Department of Fish and Wildlife

Subject: Bowman Dam Hydroelectric Project  
Docket P - 14791; Oregon Department of Fish and Wildlife Comments on the  
Pre-Application Document

### Oregon Department of Fish and Wildlife Comments on Bowman Dam Hydroelectric Project Pre-Application Document FERC P - 14791

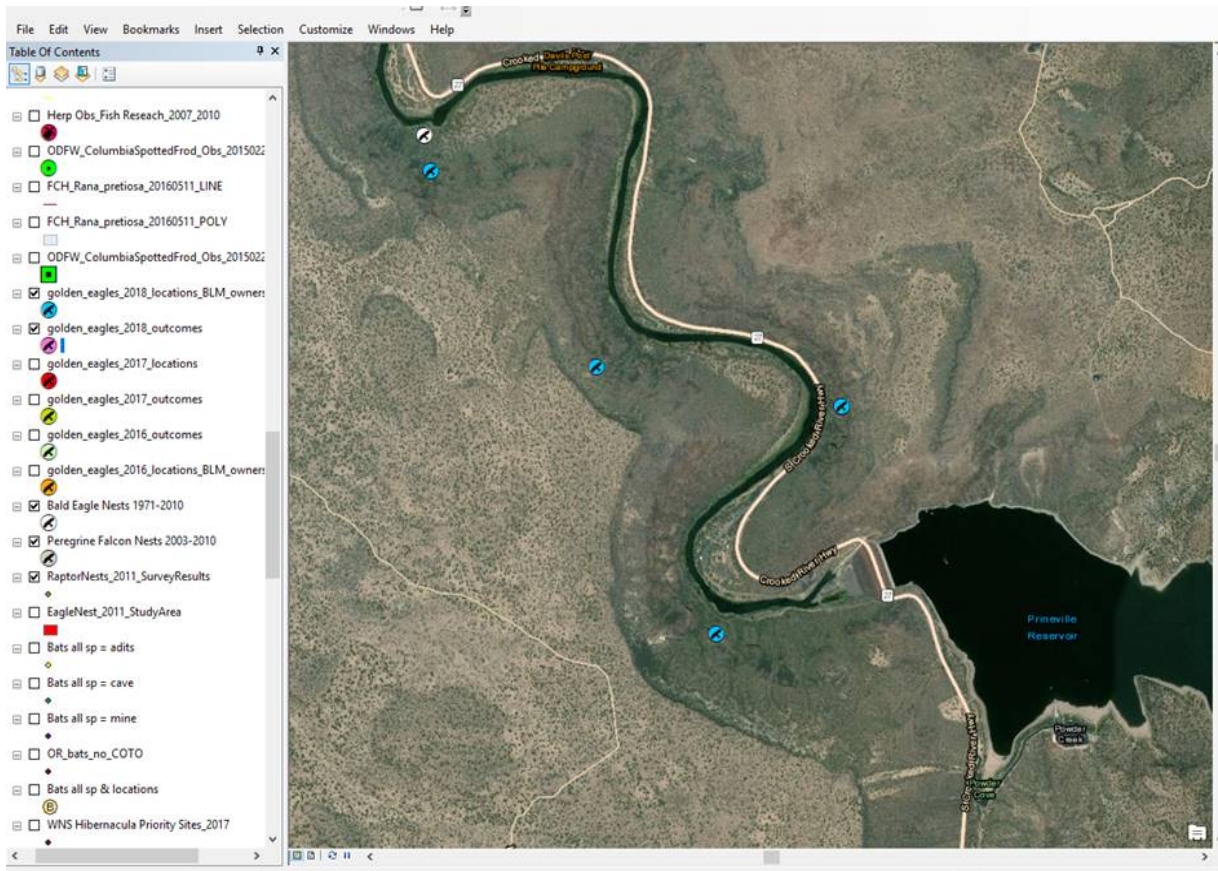
ODFW is providing the following information on raptor nest in the vicinity of the Project as a means of helping bolster section 3.2.6.1 and inform new studies and the preparation of the draft license application.
